NOTICE OF A TYPE I DECISION ON A PROPOSAL
IN YOUR NEIGHBORHOOD

CASE FILE NUMBER: LU 11-153091 LDP

Site Address: 6605 NE 23RD AVE

Denial of a two-parcel land division for attached houses.

SHEET TITLE
SITE PLAN
 SHEET NUMBER
D2

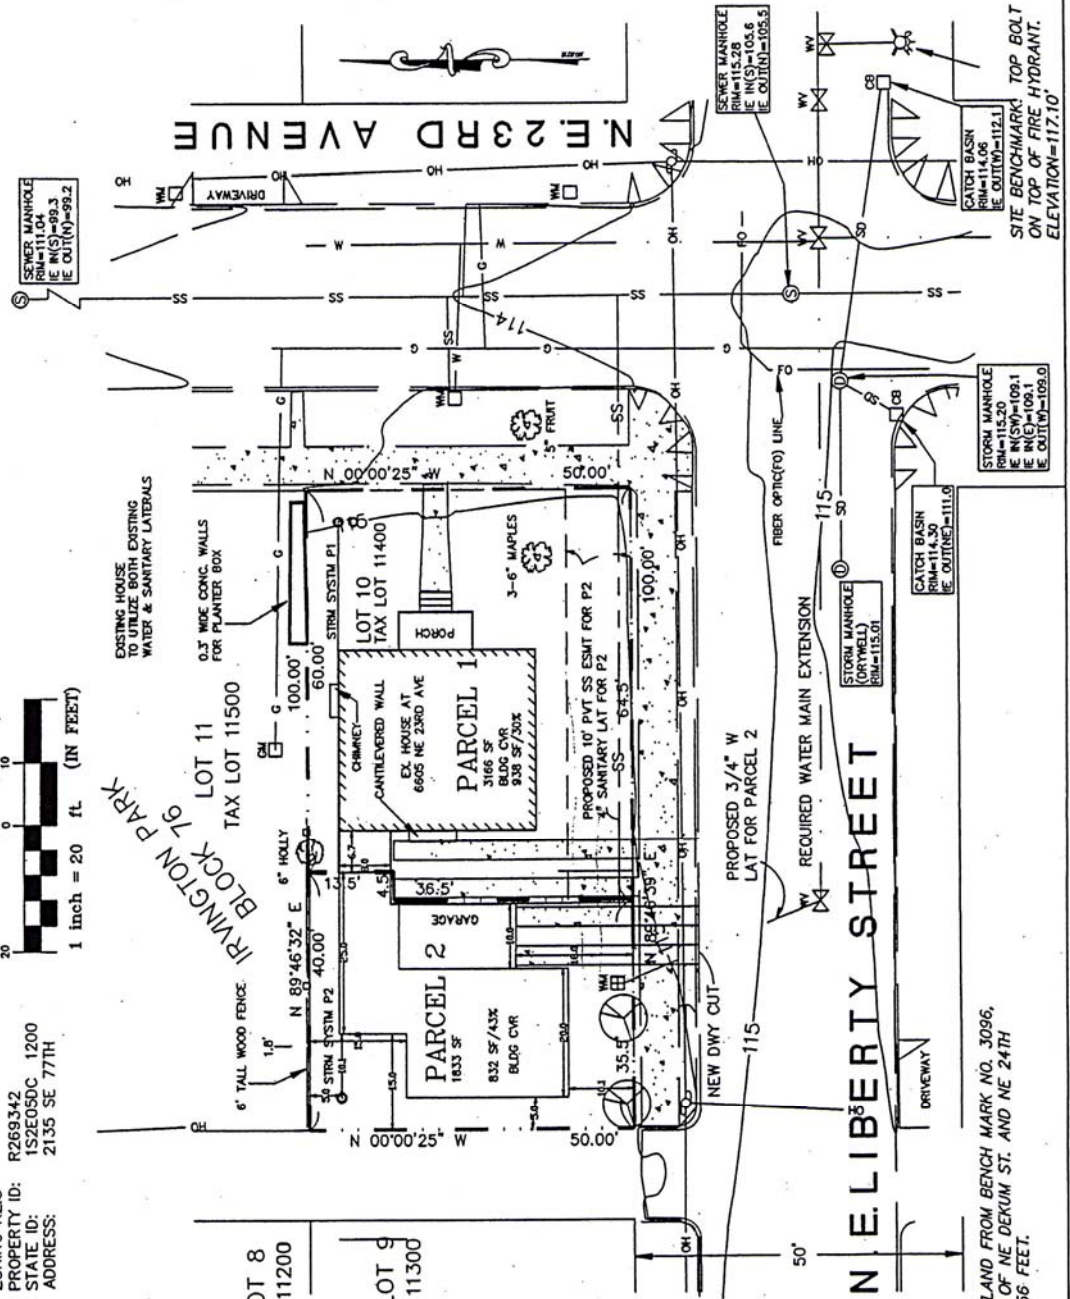
- Stormwater from Parcel 2 will be directed to a drywell that will treat the water and slowly infiltrate it into the ground. The plan submitted shows a drywell at the northwest corner of the lot, which appears to meet setback requirements.

- The applicant has not submitted enough information about the stormwater system for the existing house to determine whether it meets current requirements. Preliminary approval cannot be given unless the applicant submits additional information about the existing system, including discharge points prior to preliminary approval. This requirement is not met.

- According to City records there is an existing drywell on the property, approximately 7 feet south of the existing garage. It appears that it will be within the footprint of the proposed house on Parcel 2. A locate report and an approved plumbing permit showing its location must be submitted prior to preliminary approval. The drywell must be decommissioned and final permits obtained prior to final plat approval. However, the applicant has not submitted either the locate report or the approved plumbing permit, so this requirement is not met.
